**Tree Ad Hoc Committee Meeting
Tuesday, June 16, 2015, 9:00 – 11:00 AM
280 Madison Ave N
Bainbridge Island, WA 98110
Council Conference Room**

CHANGES RECOMMENDED AT 5/26 TREE AD HOC COMMITTEE MEETING

18.15.010.D.4 Perimeter Buffer Descriptions

**ORDINANCE NO. 2015-04
(formerly 2014-07)**

Partial Screen Plan

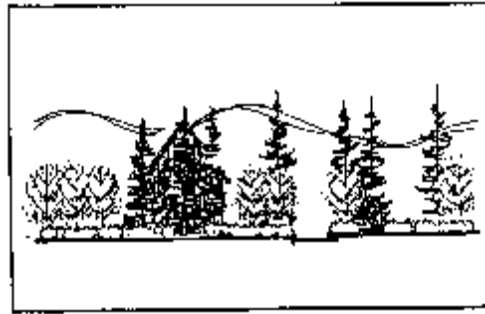
b. Landscape Buffer Partial Screen

Where partial screen perimeter landscaping is required, the applicant must provide:

- i. Minimum 50 percent evergreen trees ranging in height from four feet to six feet at the time of planting with at least 50 percent being six feet high; and

- ii. Deciduous trees with a caliper of at least two inches at the time of planting; and
- iii. At least ~~20~~ 50 percent of the trees shall be native species ~~and or~~ drought resistant; and

- iv. The number of trees is determined by calculating the area of the perimeter buffer and dividing the length of the landscape perimeter by 20 feet ~~400 square feet~~; and

- v. At least 50 percent eEvergreen shrubs at least 21 inches in height at the time of planting, spaced no more than three feet on center, to achieve minimum ~~four~~ six feet height at maturity; and

- vi. The number of shrubs is determined by calculating the area of the perimeter buffer and dividing the length of the landscape perimeter by five feet ~~100 square feet~~; and

- vii. Living ground cover shall be planted and spaced to achieve total coverage within ~~three~~ five years; and

- viii. Plants may be clustered within the landscape perimeter to screen structures and parking areas.
